**E5070B-08C**

# **S E R V I C E                      N O T E**

## **E5070B ENA Series Network Analyzer, 300 kHz to 3 GHz**

**When a measurement trace or output power shows troubles between 1.3 GHz and 2.1 GHz, replace A1 module with the latest one (E5071-6x571), and update E5070B Operating system at the same time.**

Figure 1. Trace shows noise around 1.3 GHz to 2.1 GHz at preset setting.

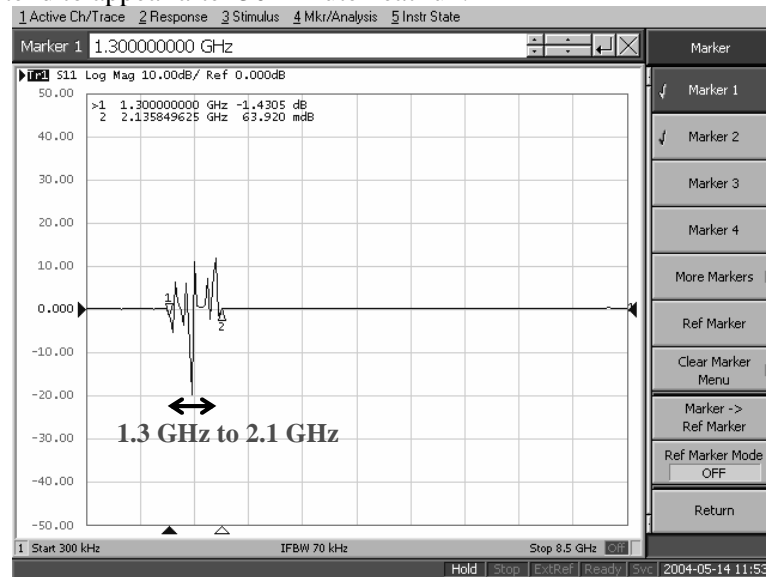
- The trace shows spike at 1.3 GHz or 2.1 GHz at the preset situation.
- The trace between 1.3 GHz to 2.1 GHz is more noisy than other frequency ranges.
- The power level of 1.3 GHz to 2.1 GHz is lower than other frequency ranges.
- Internal test of A1 ALC shows fail at SOP (f=1.3G) or LOP (f=1.3G) as Figure 2.

Above symptoms tend to appear after 30-minute heat run.

Replace the defective board with E5071-6x571, new A1 module. Also, update the operating system in accordance with the service note E5070B-10A to implement the firmware revision 5.00 or later. \*1
